[Docket No. FAA-2019-0715; Product Identifier 2019-NM-151-AD; Amendment 39-19760; AD 2019-20-07]

Airworthiness Directives; The Boeing Company Airplanes

ACTION: Final rule; request for comments.

2019–20–07 The Boeing Company:
Amendment 39–19760; Docket No. FAA–2019–0715; Product Identifier 2019–NM–151–AD.

Figure 2 (Sheet 1 of 3) Slat and Flap Inspection

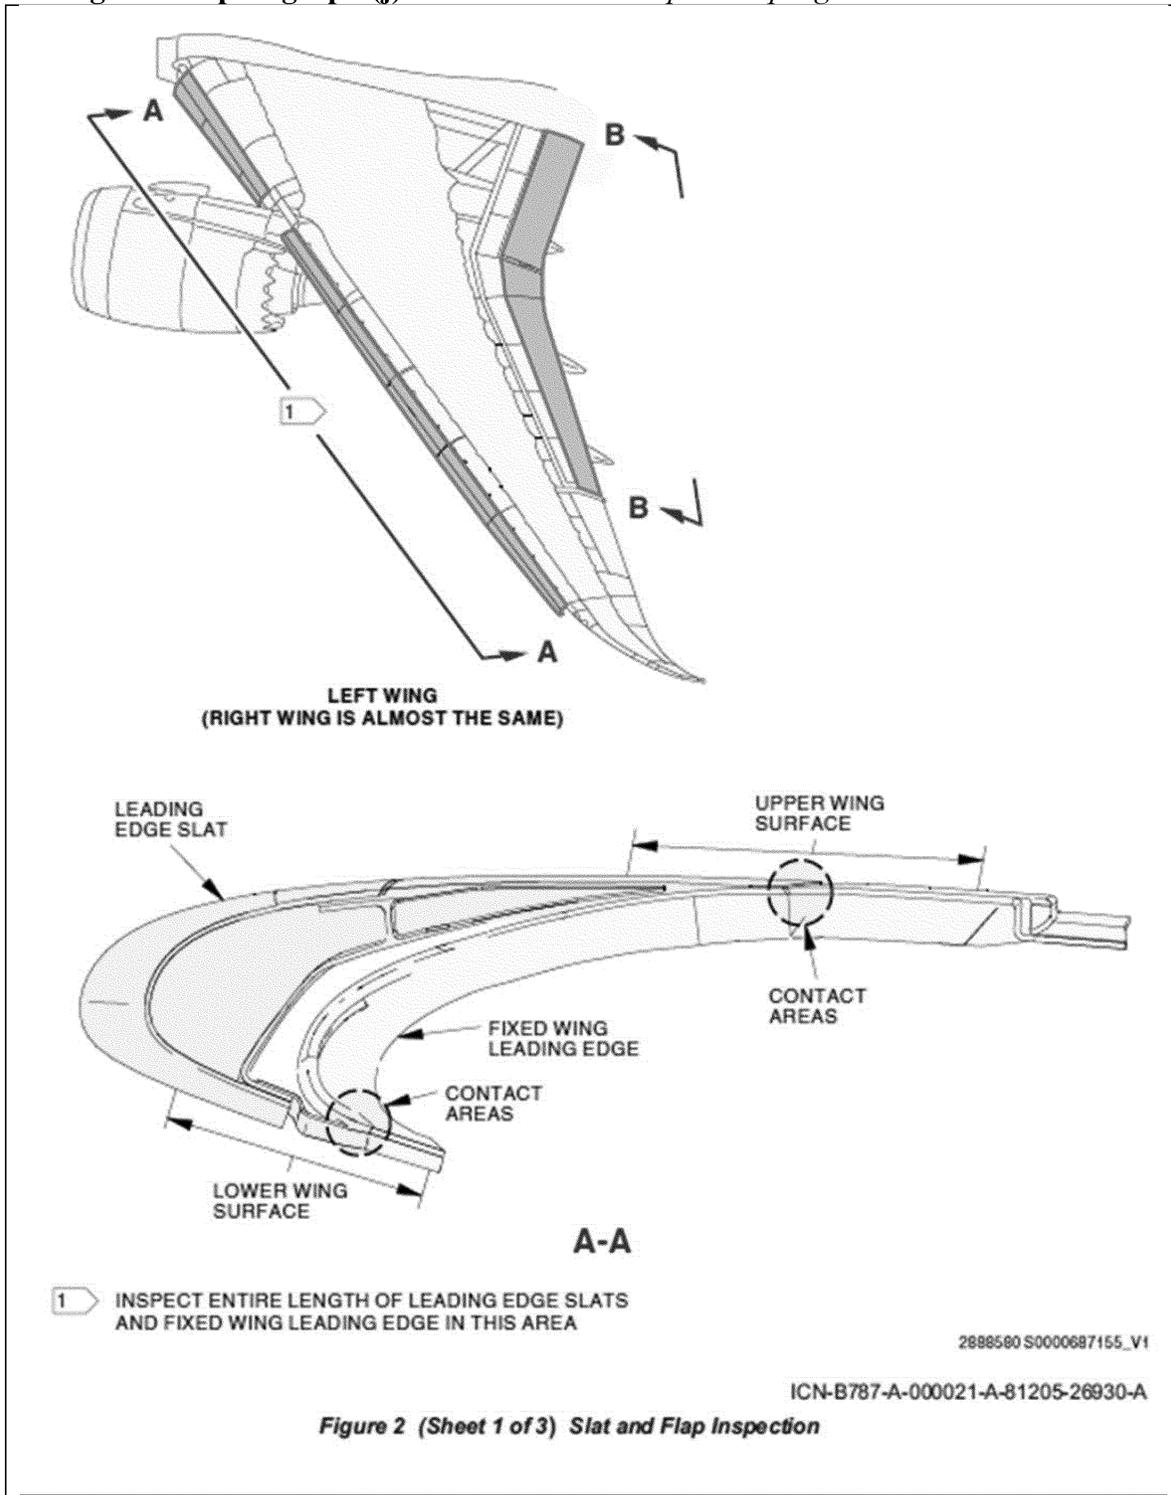
inspection program, as applicable, to incorporate the information specified in figure 2 to paragraph (j) of this AD. This may be done by inserting a copy of figure 2 to

After any landing in icing conditions, do this inspection with the slats/flaps (flaps 25 detent) fully extended (Figure 2):

- (a) Examine these areas for contaminants (ice, snow, slush):

- 1) Slats/flaps surfaces
- 2) Leading edge contact surfaces

- 3) Slat actuation areas, including exposed areas of the slat track cavity, and slat cove
- 4) Flap tracks, hinges, seals
